**Subject:** RE: Photos 12 March Okahu Viaduct and Okahu precast deck at Wilson Precasting, Otago  
- Confidential

PŪHOI TO WARKWORTH MOTORWAY

Sheet	12-11 OKAHU VIADUCT
Discipline	STRUCTURAL
Drawing No.	P2Wk-DRG-SE-19-0107
Rev	1

Subject	12-12 PŪHOI VIADUCT
Title	PRECAST DECK PLANKS REINFORCEMENT DETAILS - SHEET 3
Discipline	STRUCTURAL
Design No.	P2Wk-DRG-SE-18-0107
Rev.	1

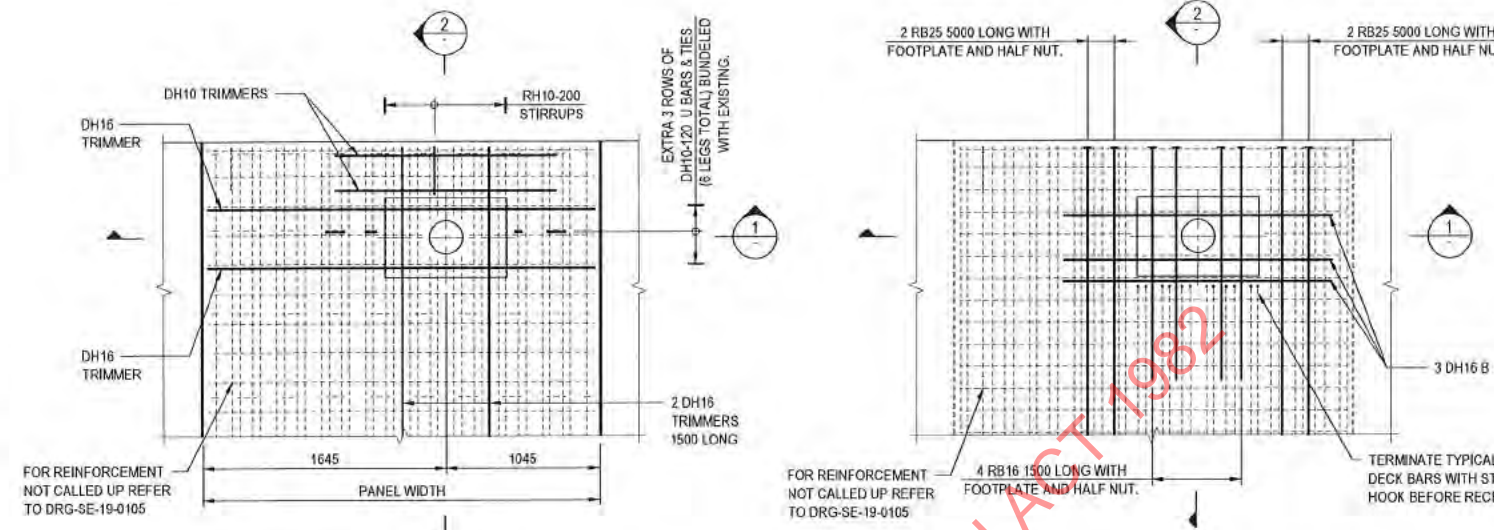
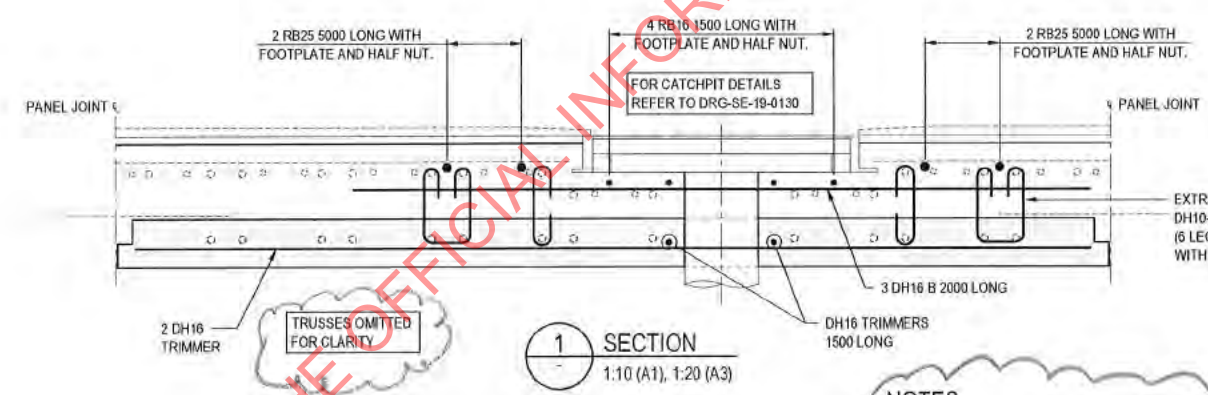
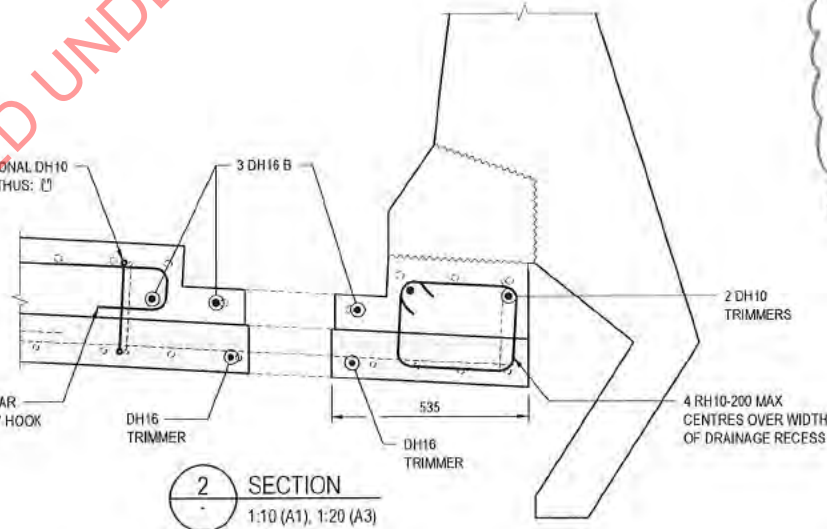
In relation to problem 2 stated below here are the relevant clauses from NZS3101 and the Bridge Manual addressing welded reinforcement in bridge decks. They were prepared for internal communication (within quotes). Also attached are extracts from the viaducts 'design report' and For Construction drawings outlining the Designers need for welded reinforcement within the viaduct decks.

The problem is the on-going effects on the deck slab behaviour due to a number of discrete changes in deck stiffness resulting from the fracture of the welded reinforcement truss. I have explained how I think the deck failure mode will be arrived at and I have implied this is likely to come about in much less than 100 years design life giving rise to both safety and durability issues. Given the stage and commercial organisation of the project stating the bald engineering will be unpalatable, but my view is s 9(2)(a) cannot be drawn into the design of a potentially flawed bridge deck system that is fraught with danger. We can assist with the design of an alternative deck system with a 100 year design life if NX2 are unable to get sign-off of the welded reinforcement truss or prove this system is adequate for 100 years.

By my calculations based on an assumed number of 6t axles and AASHTO detail classification E the Temporary Reinforcement Trusses will fail within the first year.

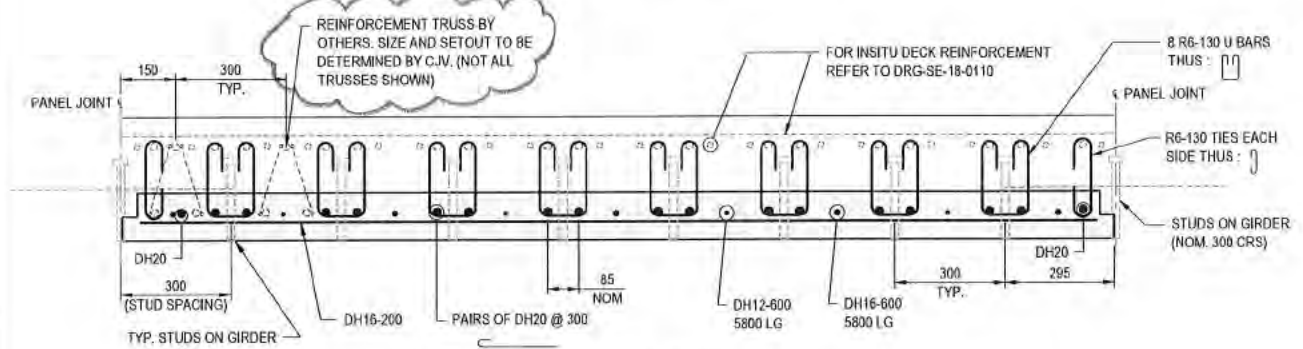
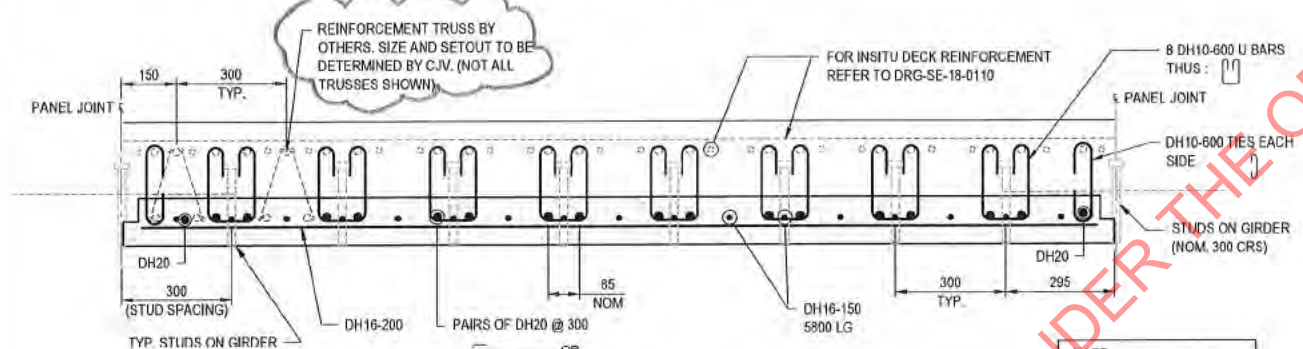
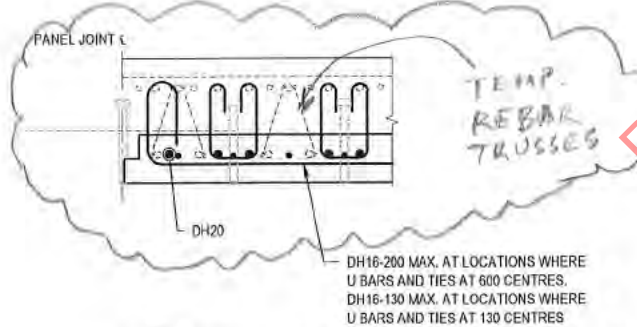
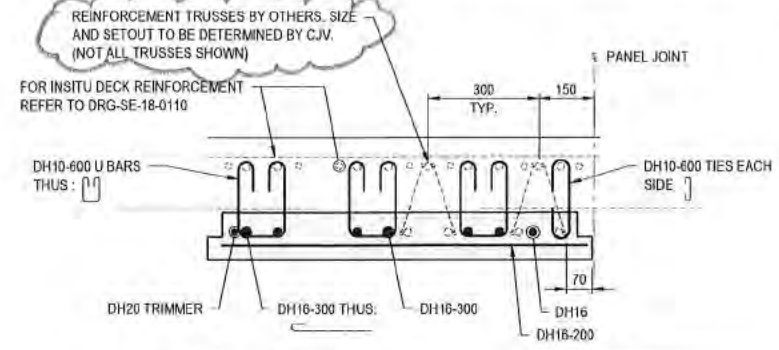
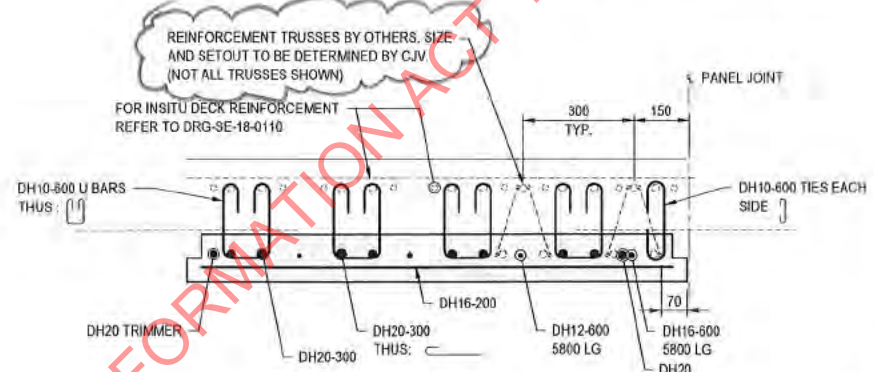
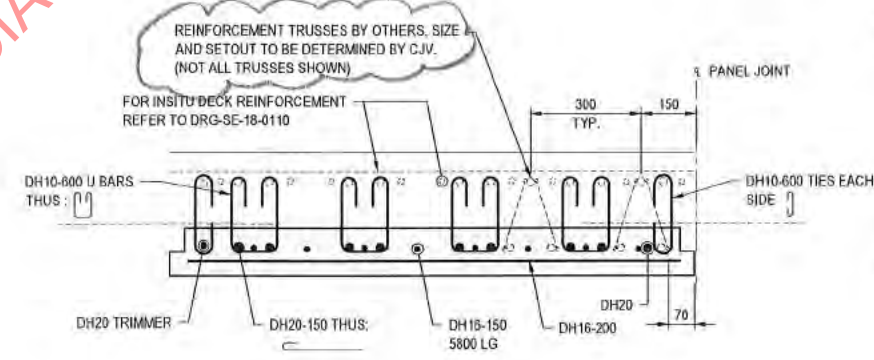
Problem	Cause
<p>1. Temporary Rebar Truss top chord buckling during topping pour preparations or during the pour. There is a considerable gap between the top chord axial capacity and the demands placed up them.</p>	<p>Acciona Ingeneria undertook a SAP 2000 FE analysis and accounted for the rebar truss and the precast concrete as both having linear elastic properties. That is the full 130mm thick precast concrete panel was modelled to carry maximum tension at the panel soffit and compression at the precast top surface. The error being the concrete cannot reliably carry any tension and only about 40mm depth of the concrete precast is immediately above the neutral axis is available to carry some small compression. Given the truss top chord is about 140mm above the neutral axis and at 'extreme compression fibre' then the vast majority of the compression loads are carried by the top chord. This prevents the high compressive strains in the concrete precast 100mm below the top chord. That is the concrete compression contributes a negligible of flexural capacity. Acciona results indicate that the precast concrete panel carry about half the required flexural capacity hence the compression demand in the top chord is about half what it should be. Acciona have taken no reasonable account of damaged to the top chord (e.g. say from a bundle of rebar being lowered onto the precast during supply for fixing the permanent deck reinforcement). Damage further reduces the top chord capacity. The erroneous Acciona analysis also indicates the precast panel deflections are much less than by elastic theory. The poorly performed load testing where the kentledge acted as a rudimentary but effective 'top flange' meant precast panels didn't deflect as much as elastic analysis indicates resulting in the precast panels not being cambered and added to the confidence that the precast panel will be suitable and disguised the top chord buckling failure mode.</p>

<p>2. High deck curvatures at locations of fatigue fractured Temporary Rebar Truss. There seems to be a gap between the allowable fatigue stress range and the actual stress range based on reasonable assumptions of detail category and number of load cycles. The longer</p>	<p>The designers clearly understood that the Temporary Rebar Truss would suffer from fatigue effects as it is mentioned in the Construction drawings. It is therefore concluded that the designers assumed that fatigue cracking will occur through the welds only; not the truss chords. (Please note that 'Temporary' is regarded as a misnomer because the trusses are permanently and completely embedded within the permanent deck slab.) Assuming a Detail Category E (from AASHTO and AREMA bridge codes) and an estimated 1 million load cycles of 6tonne axles per year it was calculated the Temporary Reinforcement Truss will fracture</p>
